**BRIAN TAYLOR**  
STATE FIRE MARSHAL

**RE: Attached Garage Considered as an Accessory Structure under the 2018 NC Residential Code  
NCRC Definition**

This letter is in response to your request for a formal interpretation from the Office of State Fire Marshal (OSFM) dated September 11, 2025, and received by OSFM the same day. Your request for formal interpretation is stated in the email attached to the request for formal interpretation:

SHEET 1 of 2

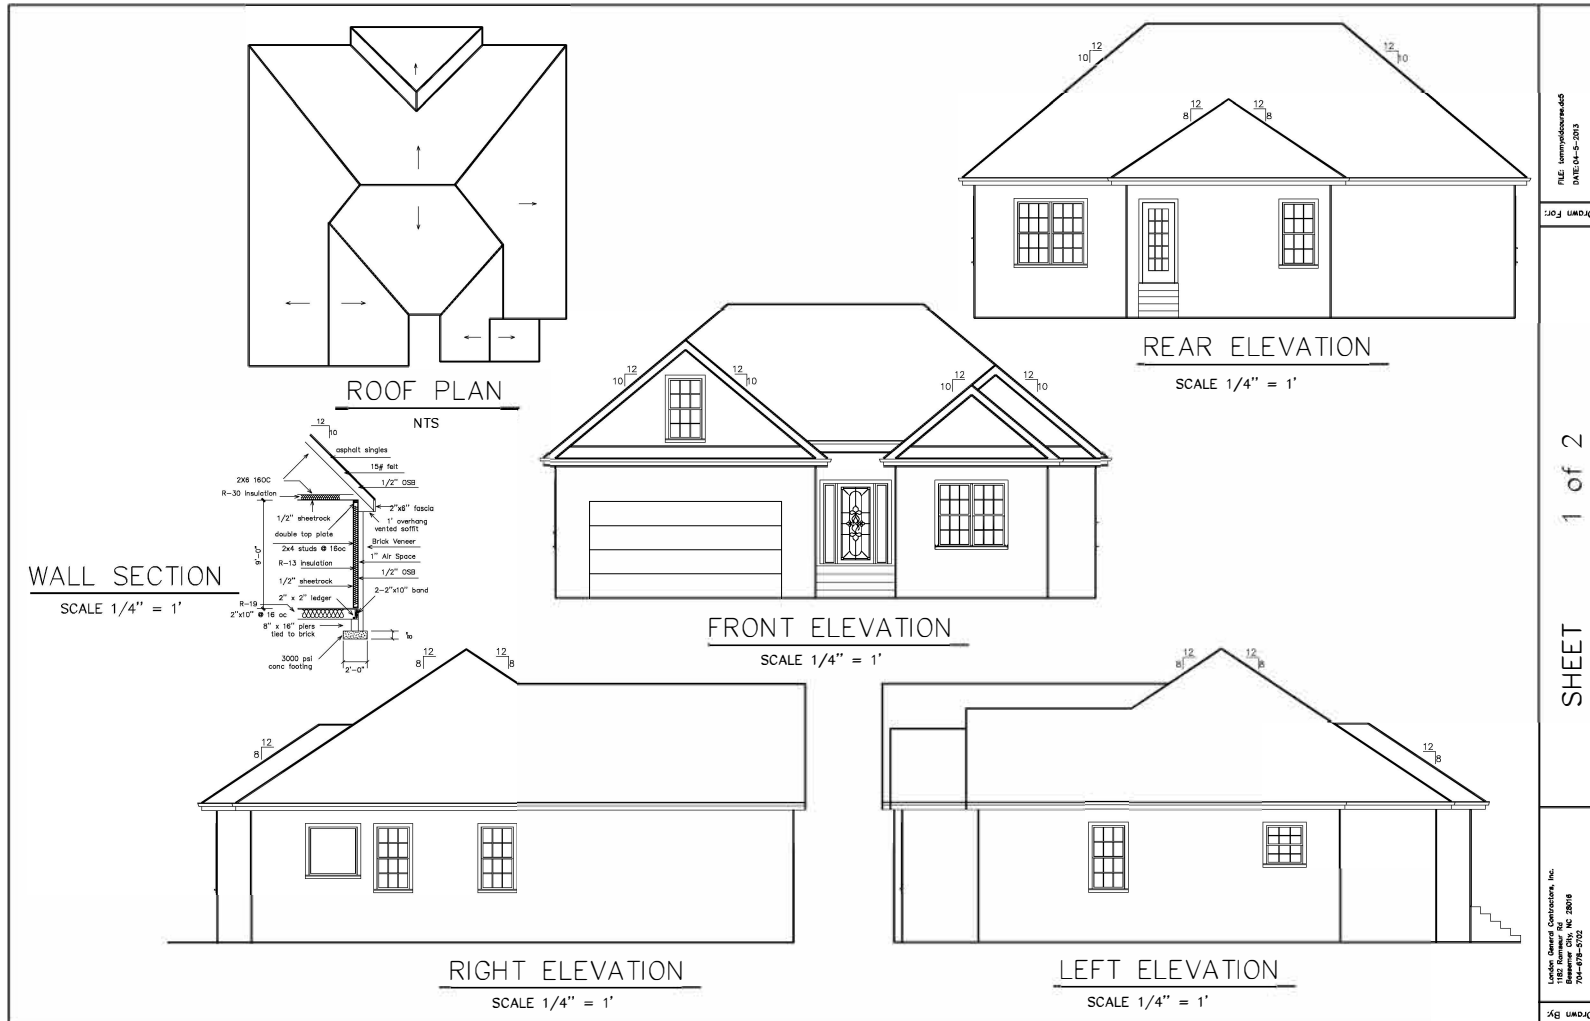
Would you please review the attached Single Family Dwelling Plan and give a formal interpretation if the attached garage is an accessory structure? Time is of the essence in this matter. Thank you for your time.

Based on the above-referenced code sections and the submitted Single Family Dwelling Plan (Attachment B), the attached garage does not qualify as an accessory building under the 2018 NCRC because it is not detached from the dwelling. While the status of being attached or detached is not the sole determinant for all accessory structures (e.g., decks or gazebos can be attached and still considered accessory

structures), the attached garage does not qualify as an accessory structure because it is enclosed, directly connected to the dwelling, shares structural elements for support (lateral or gravity loads), and is not listed among those required to meet the provisions of the code under Section R101.2.2. Given these characteristics, the attached garage is considered part of the dwelling rather than a separate accessory structure. As such, it shall not be classified as an accessory structure, and its construction must comply with the 2018 NCRC's provisions applicable to the dwelling and Section R309, including the height limit of three stories above grade plane and the prescriptive structural requirements (e.g., footings, studs, and load-bearing elements).
